RENESAS TECHNICAL UPDATE

Product Category	MPU/MCU		Document No.	TN-SH7-A727A/E	Rev.	1.00
Title	Addition to and correction of errors in the SH7280 Group Hardware Manual and SH7216 Group Hardware Manual		Information Category	Technical Notification		
Applicable Product	SH7280 Group SH7216 Group	Lot No.	Reference Document	SH7280 Group Hardware Manual Rev. 1.00 (REJ09B0393-0100) SH7216 Group Hardware Manual Rev. 1.01 (REJ09B0543-0101)		
		All lots

< Addition to and correction of errors regarding GSR3 judgment >

- (1) SH7280 Group Hardware Manual
Section 22, Controller Area Network (RCAN-ET) (SH7286 Only)
Page 1062, notes of figure 22.8, Reset Sequence
- (2) SH7216 Group Hardware Manual
Section 21, Controller Area Network (RCAN-ET)
Page 1082, notes of figure 21.8, Reset Sequence

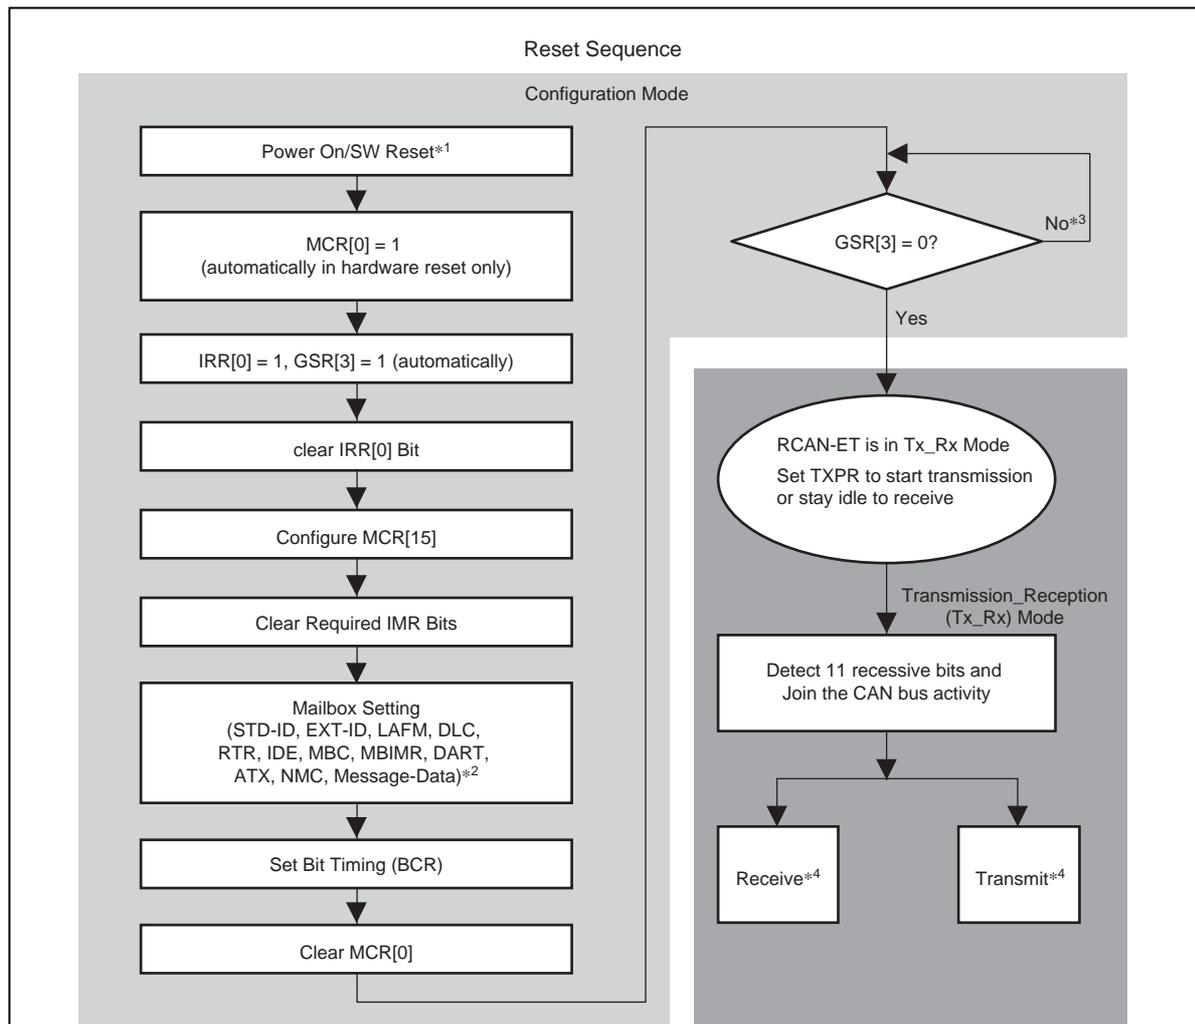
* Addition of a note 3

- Notes:
1. SW reset could be performed at any time by setting MCR[0] = 1.
 2. Mailboxes are comprised of RAMs, therefore, please initialise all the mailboxes enabled by MBC.
 3. Judgment of the acknowledgement 0 takes about 1 bit period.
 4. If there is no TXPR set, RCAN-ET will receive the next incoming message.
If there is a TXPR(s) set, RCAN-ET will start transmission of the message and will be arbitrated by the CAN bus.
If it loses the arbitration, it will become a receiver.
